Access Compliance Report Public Rights-of-Way (Curb Ramps)

Main Street: FUTURA_DR		Cross Street: FAIRMONT_BLVD		Location:	SE
ADA ID: RPAT211115111552	Ramp Type:Type 1 - Perpendicular Diagonal Initial Pass/Fail: Fail		Overall Compliance: No	Severity Score:	34
Codes/Mitigation Info/Possible Solution			Field Measurements/Component Compliance

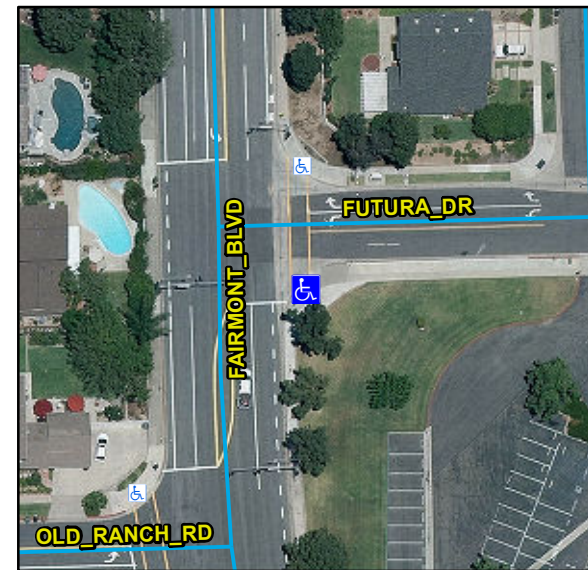
Compliance	Description	Data	Compliance	Description	Data
N/A	Ramp Length (in)	110	N/A	Flare Type LT	
No	Ramp Width (in)	47			N/A
No	Ramp Run Slope (%)	12.6	N/A	Flare Slope LT (%)	N/A
Yes	Ramp Cross Slope (%)	2.8	N/A	Flare Traversable LT	N/A
N/A	Landing Present	N/A	N/A	Flare Type RT	
N/A	Landing Length (in)	N/A			N/A
N/A	Landing Width (in)	N/A	N/A	Flare Slope RT (%)	N/A
N/A	Landing Run Slope (%)	N/A	N/A	Flare Traversable RT	N/A
N/A	Landing Cross Slope (%)	N/A	N/A	DWS Provided	N/A
N/A	Landing Movement Obstructed?	N/A	N/A	DWS Contrast	N/A
	Landing Movement Type	N/A	N/A	DWS Length (in)	N/A
N/A	Landing Shared	N/A	N/A	DWS Full Width	N/A
N/A	Clear Space	Yes	N/A	DWS Offset Left (in)	N/A
N/A	Clear Space To Crosswalk (in)	N/A	N/A	DWS Offset Right (in)	N/A
N/A	Marked Crosswalk 1	Yes	N/A	Marked Crosswalk 2	No
	Crossing 1 Direction	N		Crossing 2 Direction	W
	Marked Crosswalk 1 Width (in)	120		Marked Crosswalk 2 Width (in)	N/A

N/A	Ramp Inside Crosswalk 1	Yes	Yes	Ramp Inside Crosswalk 2	N/A
	Crossing 1 Slope (%)	0.4		Crossing 2 Slope (%)	4.1
	Crossing 1 Cross Slope (%)	4.1		Crossing 2 Cross Slope (%)	2
N/A	Gutter Ponding	N/A	N/A	Curb Slope	2.2
Yes	Gutter Lip Height (in)	0		Road Run Slope (%)	5.2
N/A	Gutter Run Slope (%)	N/A		Road Cross Slope (%)	2.1
N/A	Gutter Cross Slope (%)	N/A			
Yes	Overall Surface Condition: Acceptable		Yes	Perp Joint Present	Yes
	Cross Gutter Present?	Yes		Spandrel Present?	Yes
	Replace Cross Gutter?	No		Replace Spandrel?	No

Remove & Replace Curb Ramp With Two New Directional Ramps or Equivalent.

R304.5.1, R304.2.2, STD 1115
